From: Walter McKay <mckaywj@yahoo.com>
Sent: Tuesday, December 01, 2015 12:39 PM
To: Scott Weeks
Subject: Fleet Morris Shell Paving Plan

From: Lisa <lisa.williams99@gmail.com>
Sent: Tuesday, December 01, 2015 10:07 AM
To: Scott Weeks
Subject: FLEET MORRIS new SHELL site at Gluckstadt Rd

PROJECT NUMBER B-4179	SHEET NUMBER TP-1	PROJECT: FLEETWAY FUEL CENTER	PROJECT LOCATION: GLUCKSTADT ROAD MADISON COUNTY, MISSISSIPPI	DATE: 11/27/19	DRAWN: DCJ	REVISIONS:
		SHEET CONTENTS: PRELIMINARY TRUCK PARKING SITE LAYOUT	OWNER: MORRIS REAL ESTATE, LLC MADISON, MISSISSIPPI 39110	CHECKED: GAB	SCALE: 1"=20'	
				REF. CAL:		
				CG SURFACE:		
				FG SURFACE:

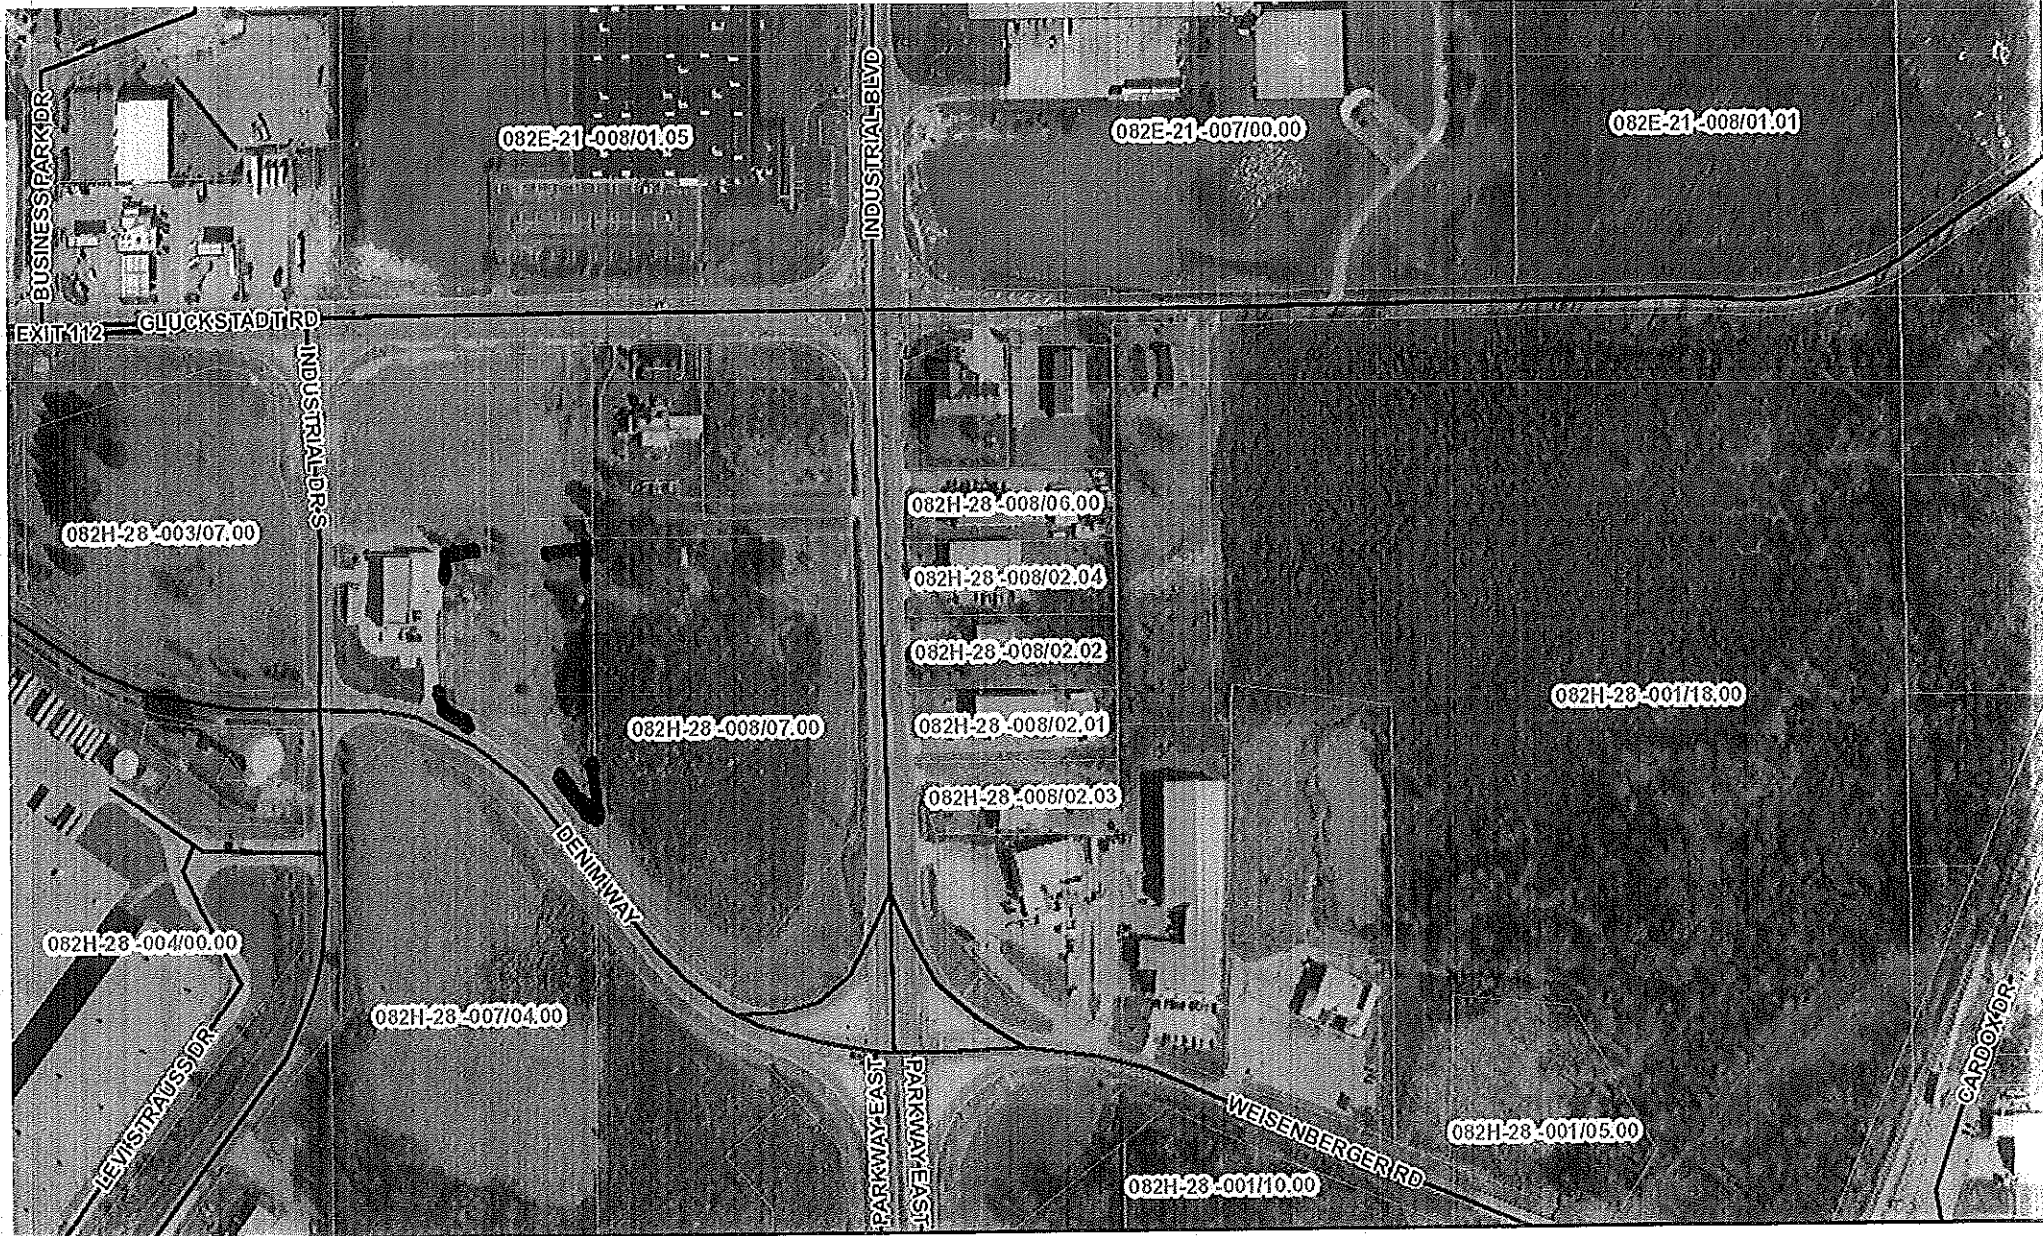
The only concern to be responded to a this point is Mr Walter McKay questioned the structure drain or "spillway structure"

This is noted on the plan Bradley showed us but NOT visible at the site. At the site is 2 concrete drains running off into one at the road. The specs show from 36" pipe to 18" pipe...

Developer did a good thing by adding drainage grates around the building area but we have concerns this draining at the rear of the lot is not going to be sufficient.

Engineering company is to get a visual at the site and get an answer to Bradley to get to Walter.

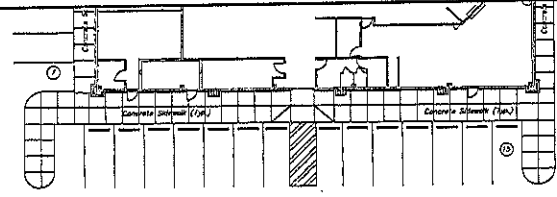
Just a point of explanation on Lisa's email to you regarding the drainage/retention basin on the new site plan submitted, which does not show the drainage system. I did review the drainage system at the site on the construction plans, however.

I've not seen the engineer's drainage calculations, etc., nor the philosophy behind their plan. I understand Warnock's office was provided calcs for approval. I commend them for the extensive drainage system provided for the site and adjacent street and property. I do understand that an 18" culvert on the outfall end will not handle all the water that the 36" pipe can deliver if it were flowing near full, thus creating some ponding in the "detention" basin. Construction plans indicate a paved ditch invert between pipes which indicates at any low flow water will not be retained. I don't see this as a problem, if approved by the County.

However, the paving site plan submitted has a note which says there is an "emergency spillway", but it's not identified on the construction plans, nor where water would go if the "spillway" is over topped. My question was, and is, is there supposed to be constructed a spillway structure at the 18" outlet pipe? The note on the drawing indicates so but approved construction drawings do not include it. Mr. Morris was to get further info on this as a matter of clarifying the construction intent.
